PLANNING COMMISSION REPORT
Non-Public Hearing Item

PC Staff Report
05/23/2016

**ITEM NO. 2 FINAL DEVELOPMENT PLAN FOR BAUER FARM ZAXBY'S; 4661
BAUER FARM DR (SLD)**

FDP-16-00104: Consider a Final Development Plan for Zaxby's, a Fast Order Food with Drive-In, located at 4661 Bauer Farm Dr. Submitted by Carter Engineering Consultants, Inc., for JULI, LLC, contract purchaser, Free State Holdings Inc, property owner of record.

Figure 4: Location for additional pedestrian ramps

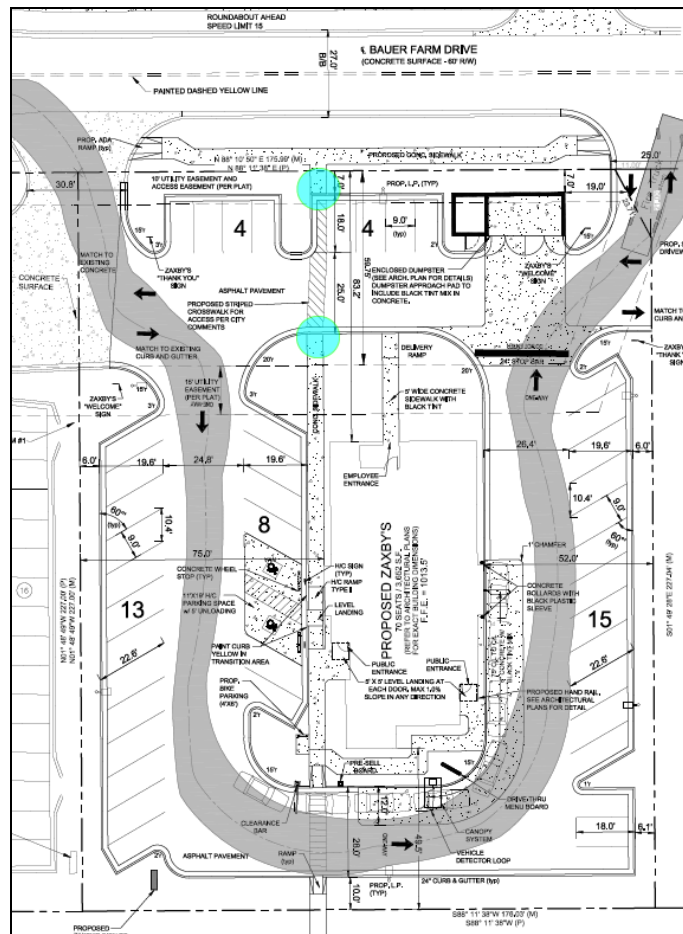
Much of the needed infrastructure exists for this site. The applicant will be responsible for connecting service lines between the building and the water and sanitary sewer main lines. Sidewalk is located along Bauer Farm Drive and W. 6th Street. This project will relocate the sidewalk along Bauer Farm Drive in anticipation of construction of the on-street parking along the south side of Bauer Farm Drive. The City Traffic Engineer noted that "Pedestrian pathway to Bauer Farm Drive needs ramps where appropriate." The plan should be revised to show the ramps as noted.
